CITY OF WESTMINSTER
Special Mayor and Common Council Meeting
Wednesday, June 3, 2020 at 2 pm
<https://www.facebook.com/westminstermd/>

Re: Approval – Warner Construction Contract Change Order Nos. 5, 6, and 7

Re: City of Westminster Administrative Office Building Renovations & Alterations
Project no. 20-02

Name Westminster Administration Building
Address 45 W Main Street, Westminster, MD 21157
Date of Contract: 11/25/2019

Question:

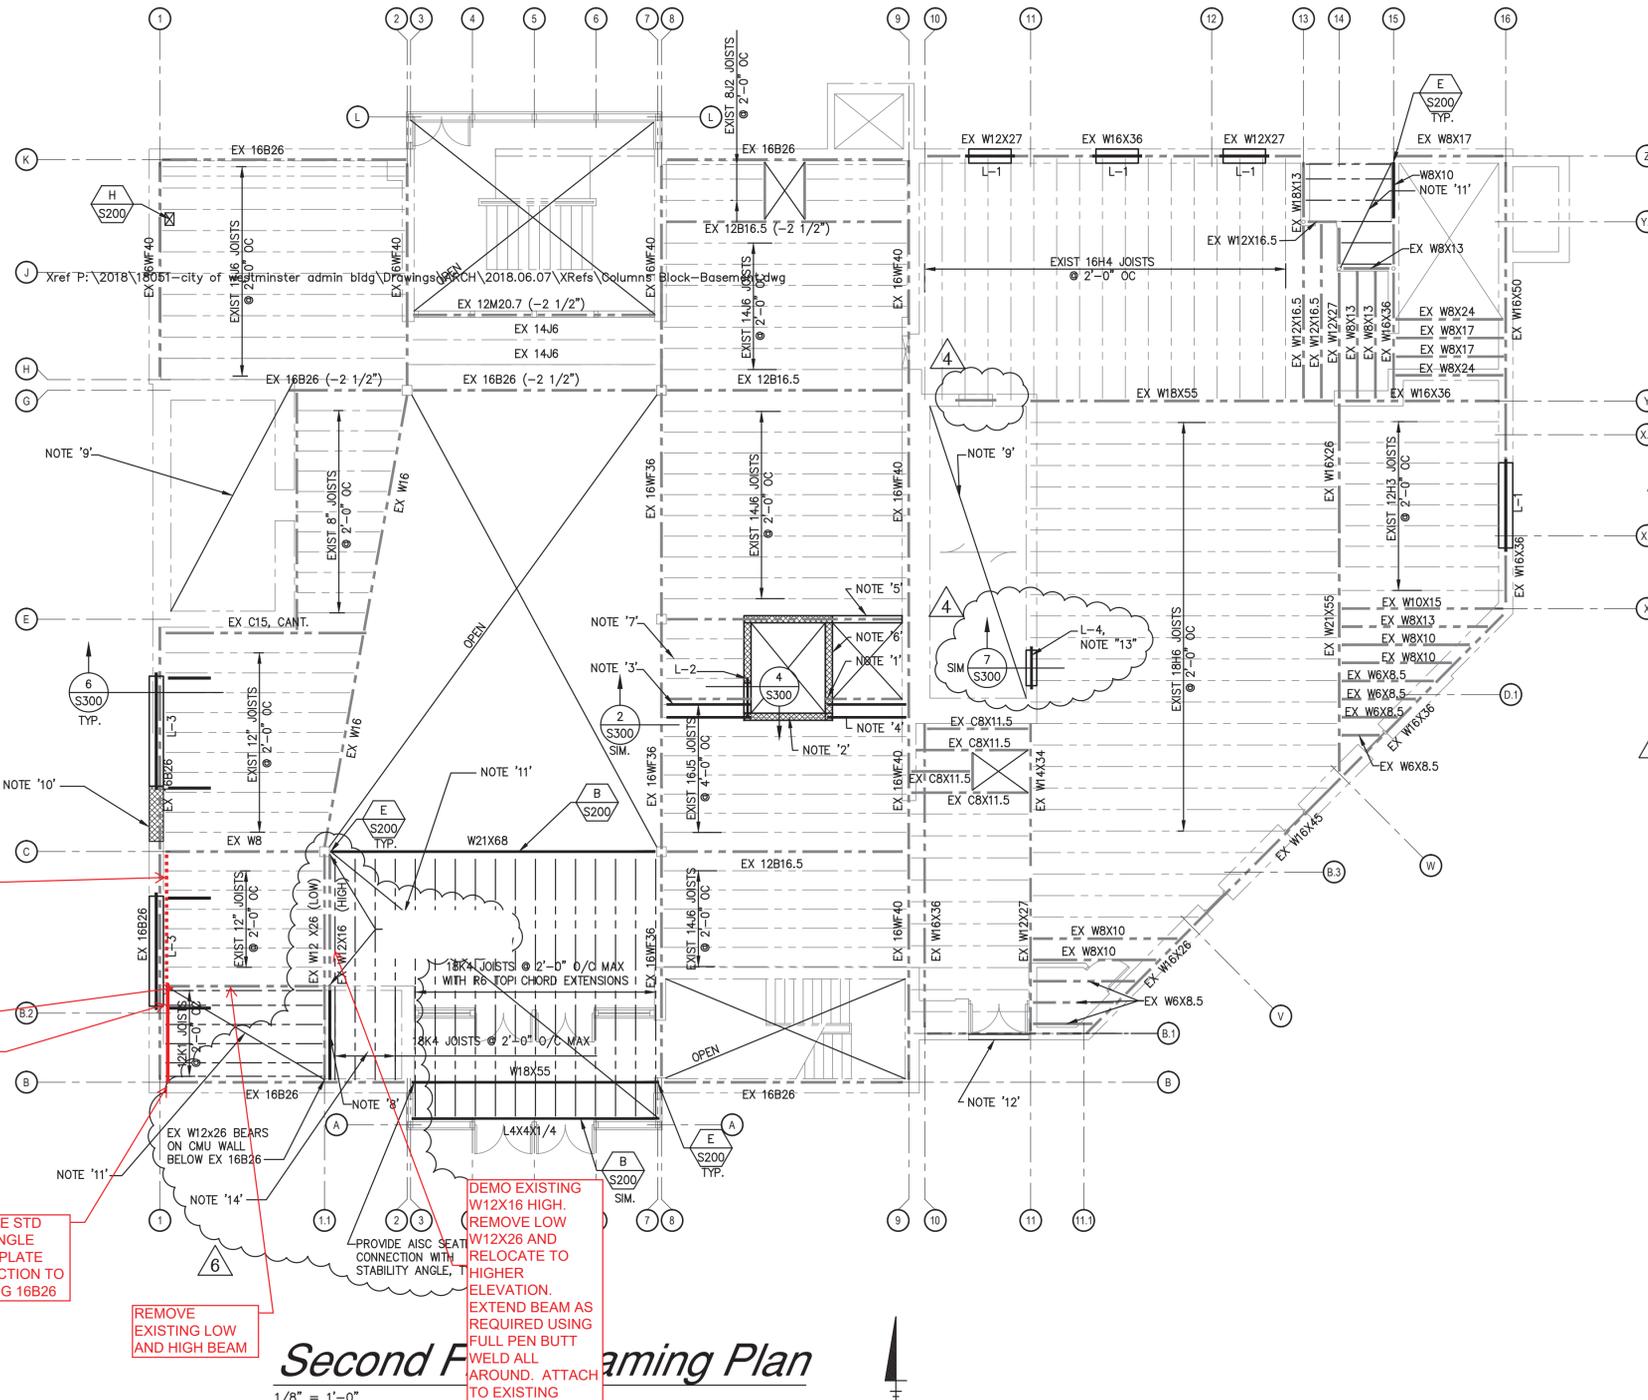
Can you look over these 2 changes that my steel subcontractor picked up:

1. See attached SK235A – the 6 pieces of J4 joists were ordered 3 1/2” too short see sketch for possible solution.
2. See CL 1.1-C – existing column only has a 6 1/2” wide flange. The connection angles and web thickness of the W21X68 beam are 7 11/16” wide. Can we utilize a seat angle and roll clip here as we are at the beam on line B.

1. Contractor to provide pricing for the (2) solutions described on attached sheets S102 – Options A & B. Pricing to be reviewed by Owner to determine which solution to be executed; final direction to be given following price review. Both options will resolve issue of the joists being too short.
2. A STD AISC Seated connection with stability angle (roll clip) is acceptable.

OPTION - A

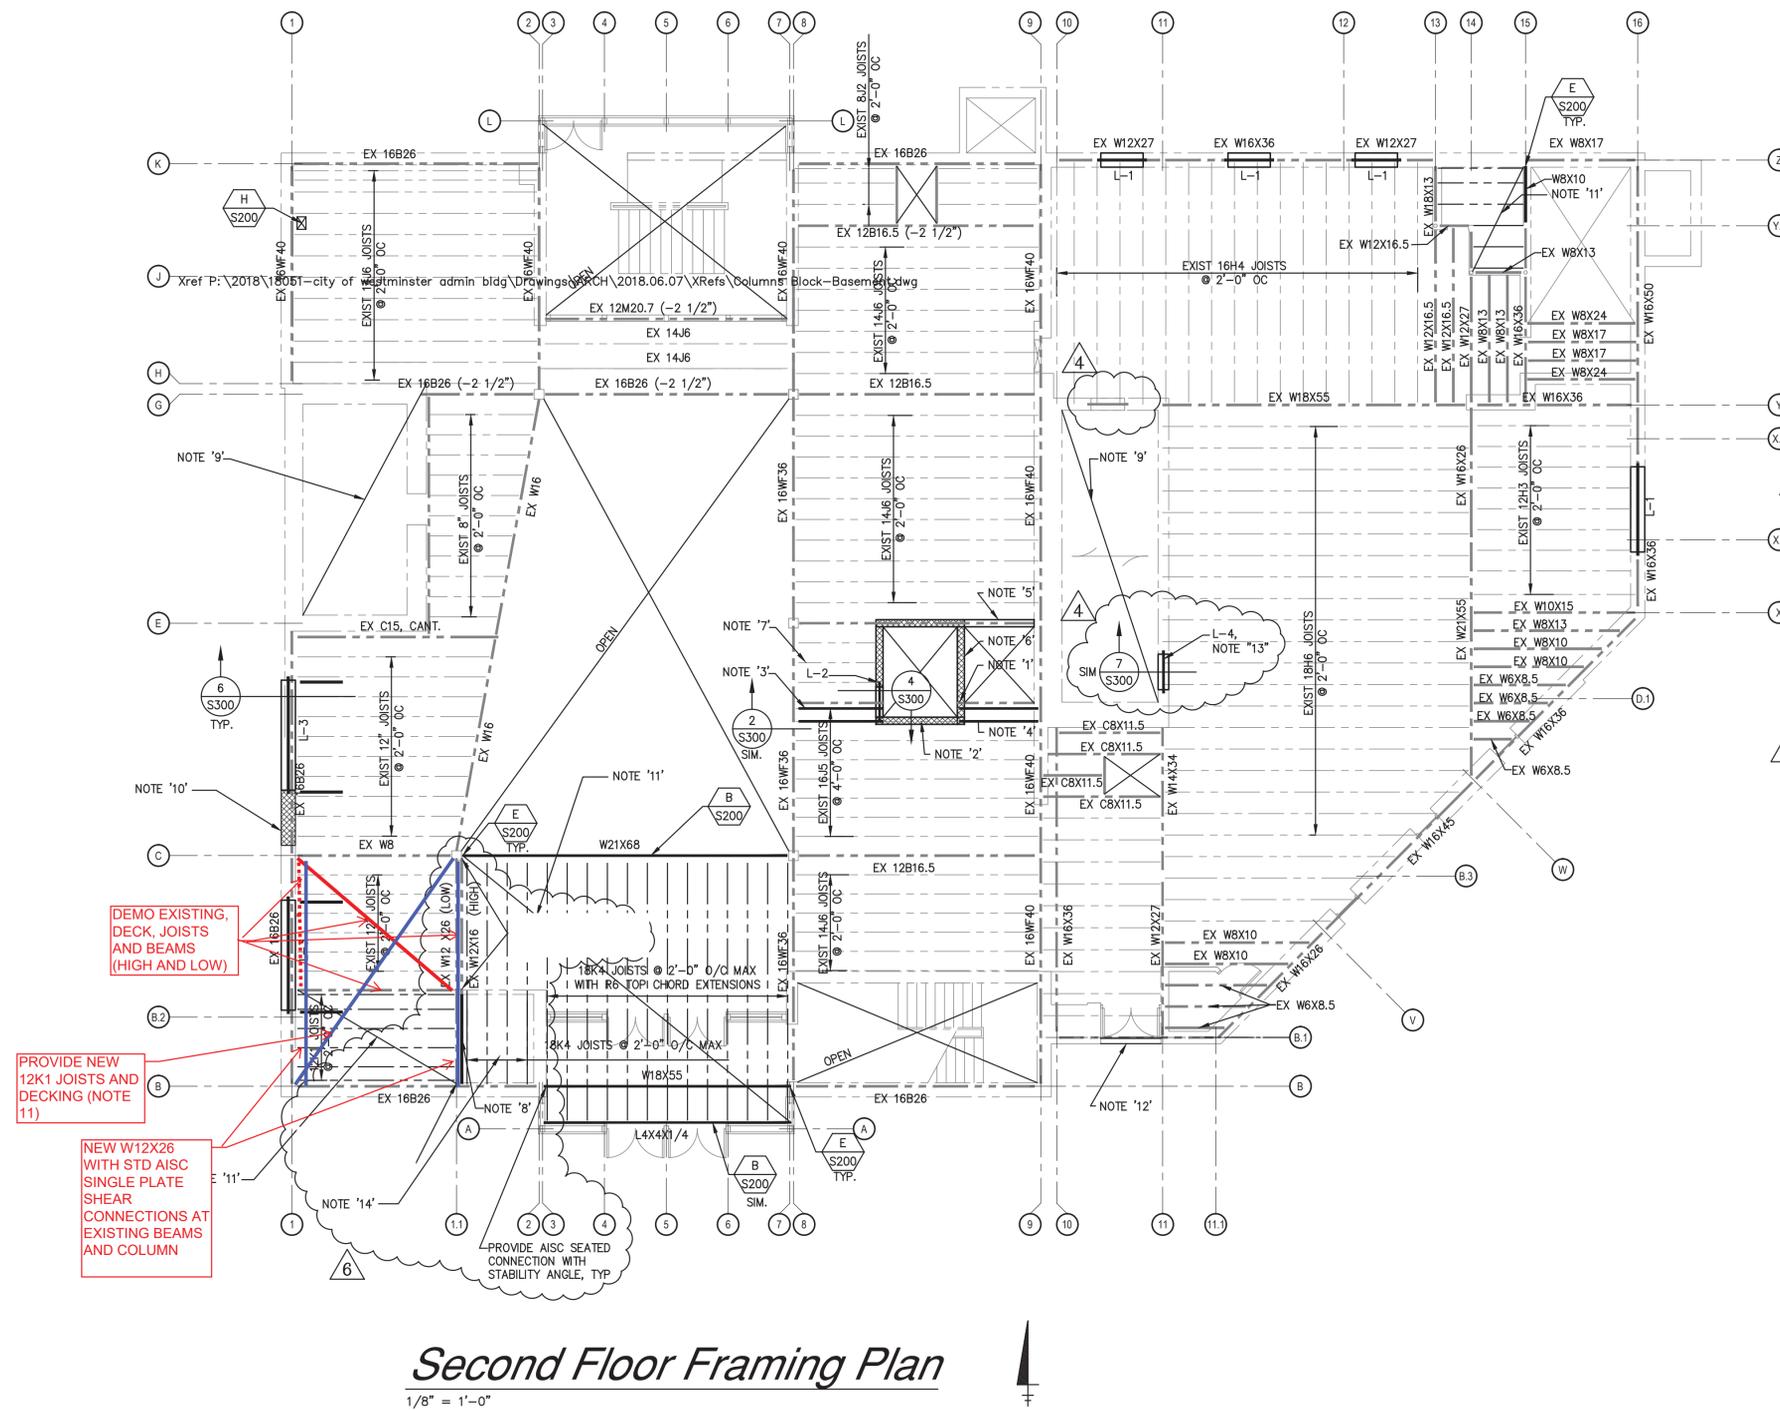
EXISTING 18" DEEP BEAM. GC TO VERIFY DEPTH FLANGE WIDTH AND THICKNESS (W18X35 USED FOR BASIS OF DESIGN)

GC TO SHORE EXISTING STRUCTURE TO FACILITATE BEAM EXTENSION

EXTEND EXISTING W18 WITH SAME MEMBER. PROVIDE FULL PENETRATION BUTT WELD ALL AROUND.

PROVIDE STD AISC SINGLE SHEAR PLATE CONNECTION TO EXISTING 16B26

REMOVE EXISTING LOW AND HIGH BEAM

DEMO EXISTING W12X16 HIGH. REMOVE LOW W12X26 AND RELOCATE TO HIGHER ELEVATION. EXTEND BEAM AS REQUIRED USING FULL PEN BUTT WELD ALL AROUND. ATTACH TO EXISTING COLUMN AND BEAM USING AISC SINGLE SHEAR PLATE. RE-ATTACH EXISTING BAR JOISTS

DEMOLITION PLAN - GROUND FLOOR
SCALE: 1/8"=1'-0"

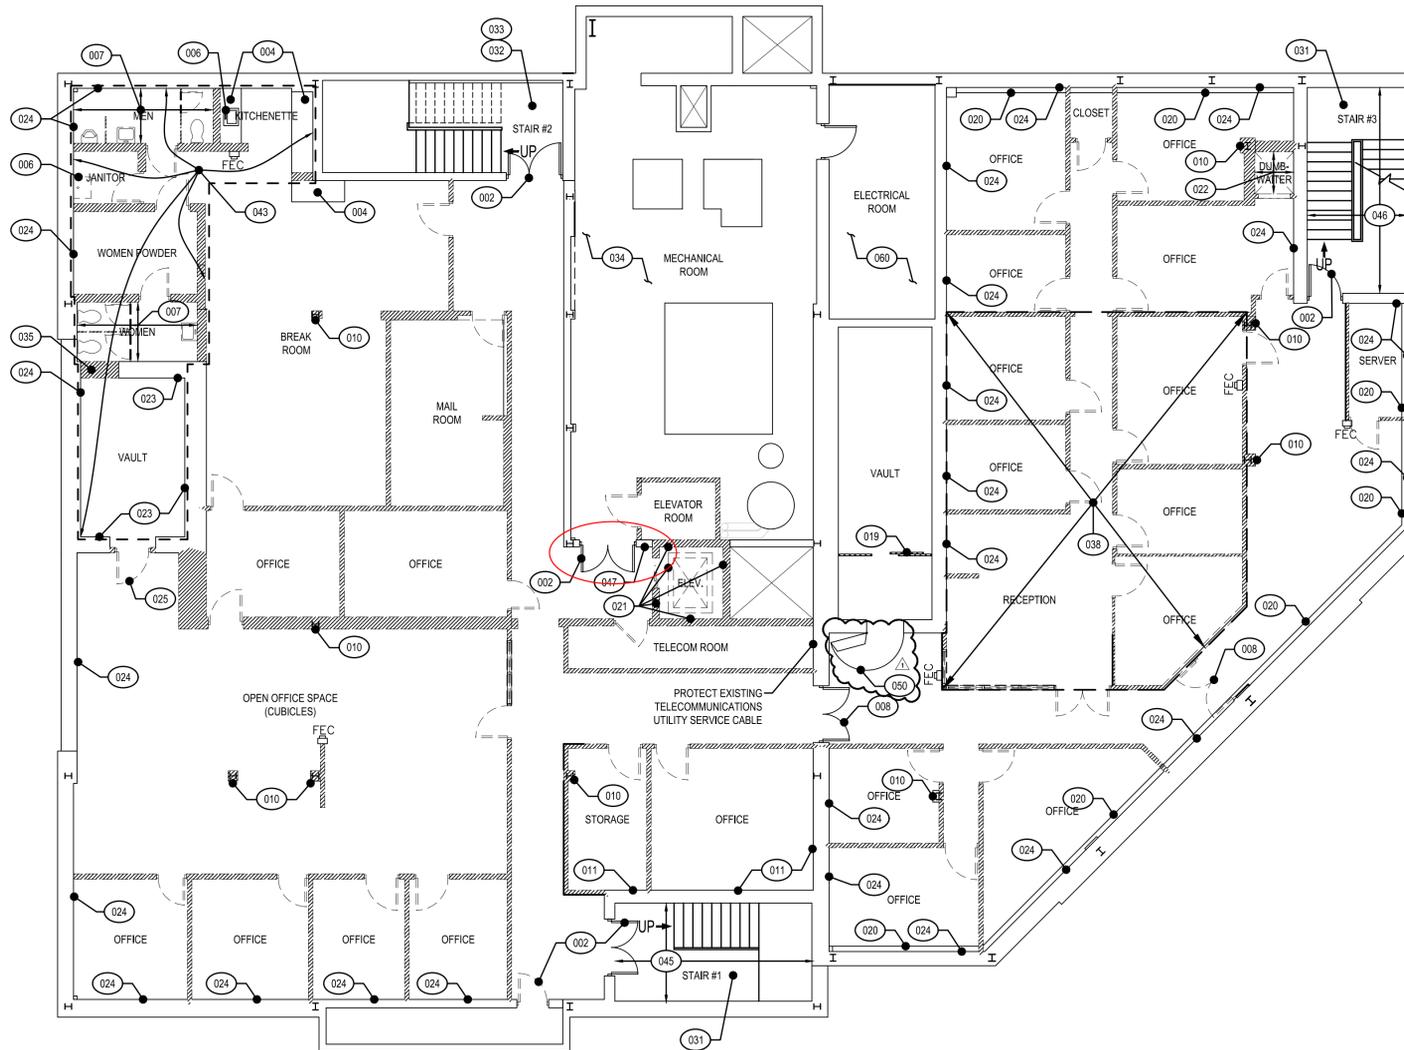
We are pleased to offer the following pricing to make the following changes:
Tear out block wall for safe demo and safe conditons for concrete and proper construction on new walls and elevator pit (Design Issue)
Tear out door frame and door
Demo Footing not shown shown on S100 to accomadate new pit construction

The scope of work involved in this modification is necessary to allow for construction of the new elevator pit and hoistway. During demolition, several large concrete footings were uncovered that were not shown on the as-built drawings from previous renovations and had to be removed to clear the way for the new elevator pit foundation. Also included in this price is work to remove and rebuild a CMU block wall that was scheduled to be remain, but once the additional footings were discovered, this wall needed to be undermined to fully demolish the unforeseen concrete masses; thus, requiring this scheduled to remain wall to be demolished.

Foundation Plan
1/8" = 1'-0"

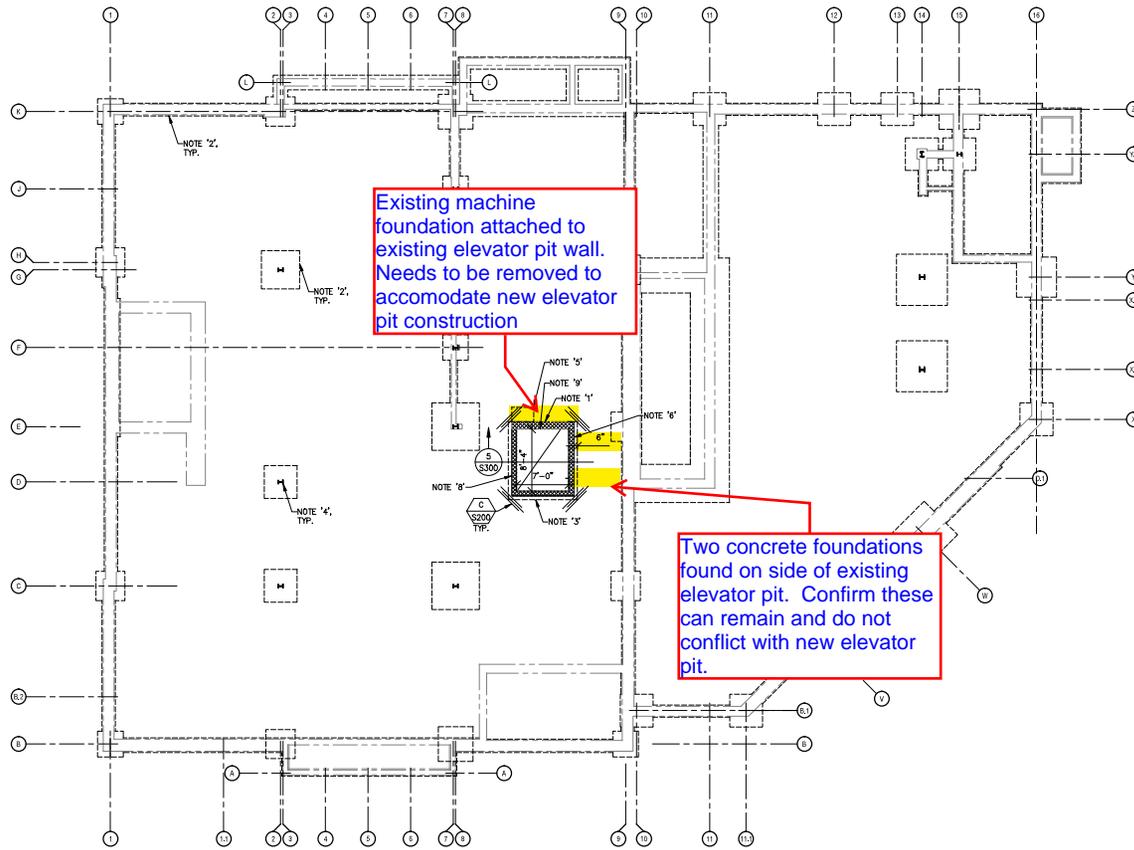
1. 12" O.M.U. TO FIRST FLOOR SLAB, THIS WALL ONLY. REINFORCE AS WITH 8" O.M.U. ELEVATOR WALLS.
2. EXISTING FOOTING. TYP.
3. TOP OF NEW ELEVATOR PIT SLAB TO BE 82.00'S. GC COORDINATE WITH ELEVATOR MANUFACTURER.
4. EXISTING STEEL COLUMN. TYP.
5. EXISTING 4"-3" DEEP MACHINE FOUNDATION.
6. 8" O.M.U. REINFORCE WITH #5'S AT 1'-4" O.C. FILL CELLS SOLID WITH GROUT AT REINFORCEMENT.
7. TOP OF EXISTING SLAB = 86.0'S.
8. EXTERIOR FACE OF WALL TO MATCH EXISTING.
9. INTERIOR FACE OF WALL TO MATCH EXISTING.

FIRST FLOOR PLAN

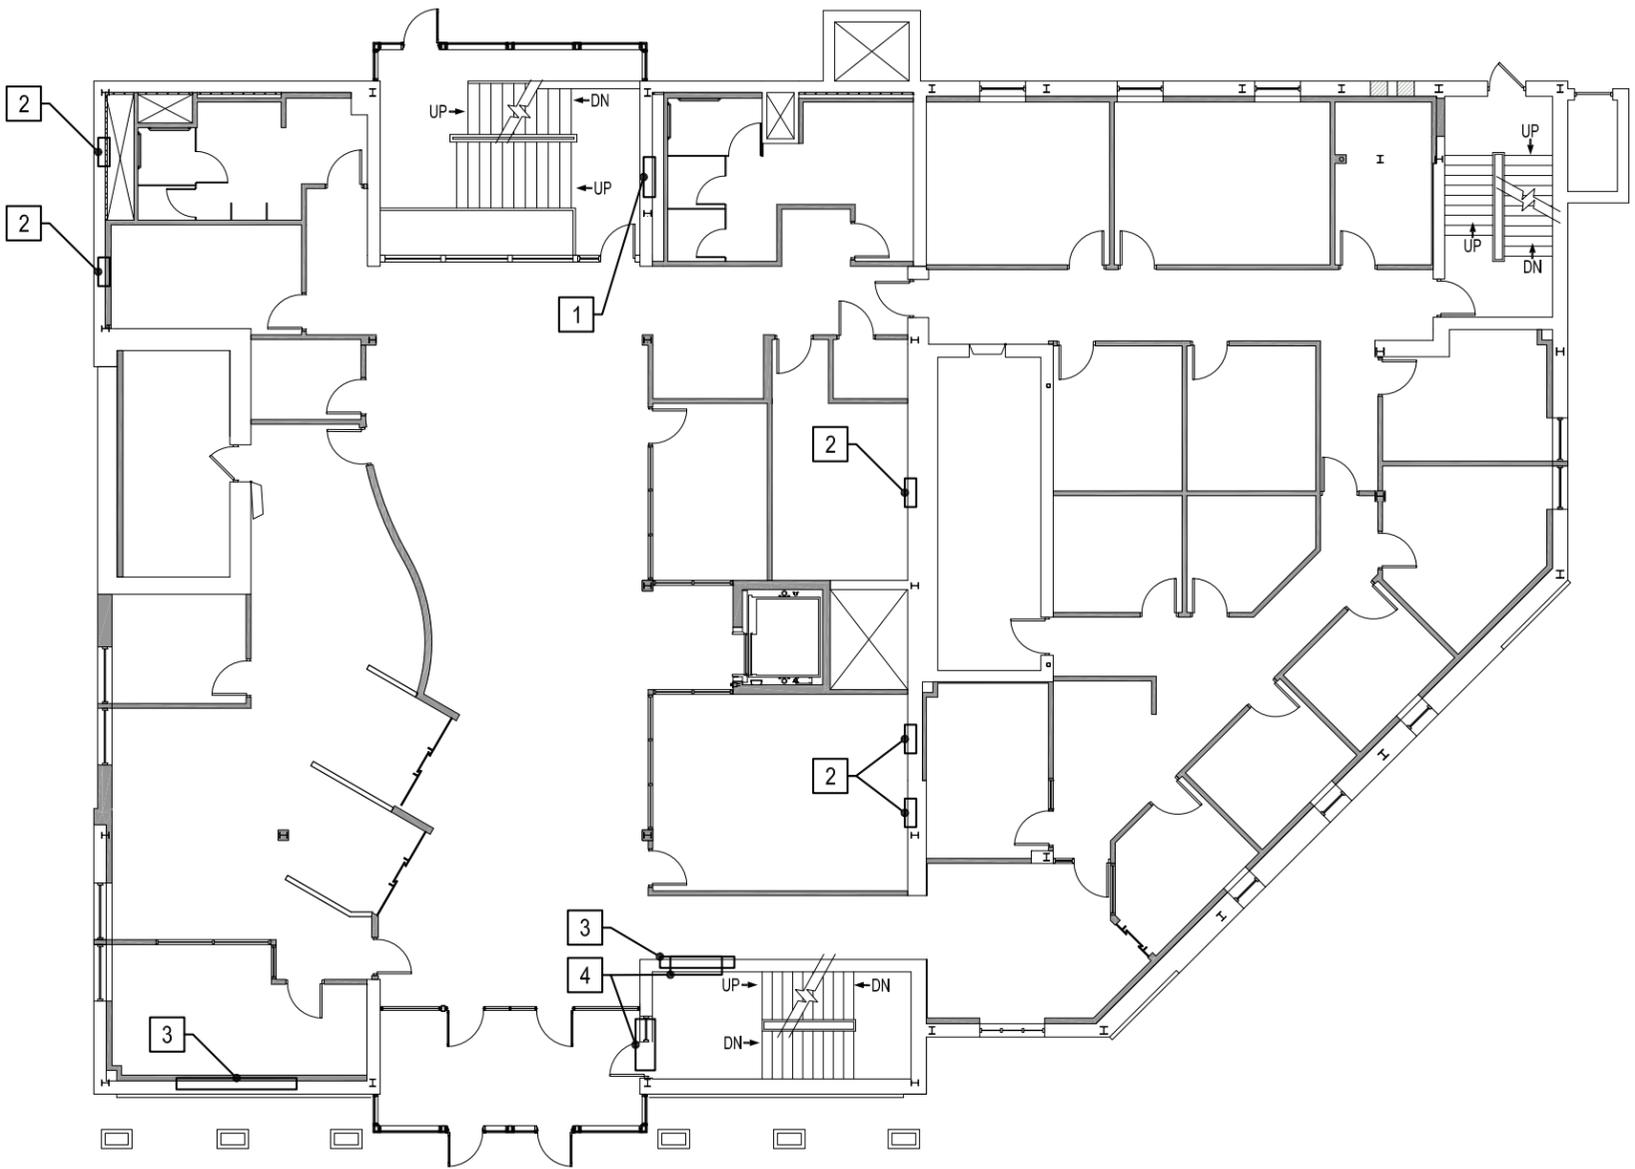
- 5 Abandoned HVAC Passages Through Stair 2: (3)
Infill abandoned HVAC duct passage through CMU block wall using masonry to match existing; tooth new masonry into existing. Install fire stopping as needed to seal deck penetration.

The scope of work involved in this modification is necessary to ensure that all abandoned floor deck and rated stair penetrations are sealed and structurally sound following the demolition of the existing HVAC system. The previous system utilized cavities in the exterior CMU block walls to supply and return air. These cavities have since been abandoned with the new HVAC system, and need to be infilled to ensure proper fire/smoke separation between floors and stairways, as well as to eliminate these cavities as possible weak points in the wall.
